# RE: Comments on TDECQmax Reduction by 0.2dB (#33, 34)

IEEE P802.3cn May Interim, Salt Lake City, UT, USA, May 20<sup>th</sup>, 2019

# Yield Impact for QDD LR8 Modules

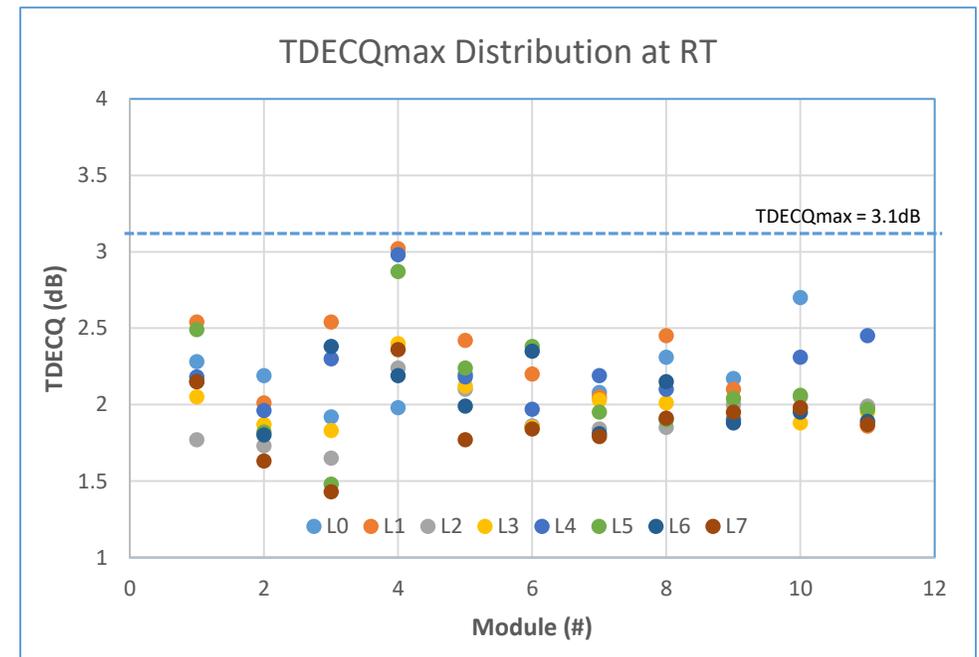
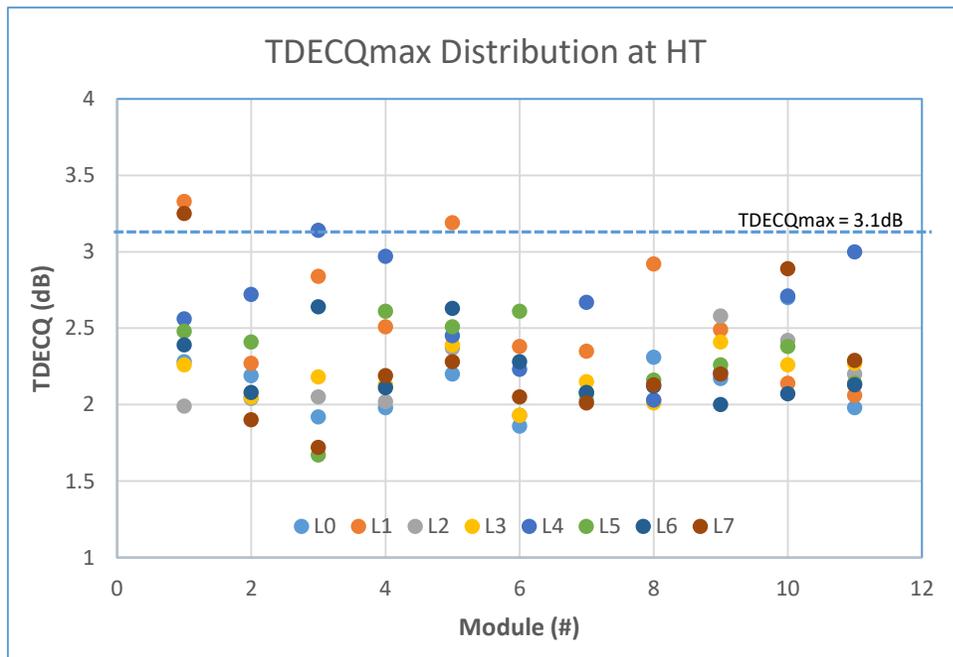
- We look into 11 known good LR8 production samples for measured TDECQ values (all <3.3dB by production process), it turned out the module yield impact would be as high as 27% due to TDECQmax change from 3.3 to 3.1dB.
  - It would impact TxOMA-TDECQ as well.
  - The test was done with SSPRQ pattern.
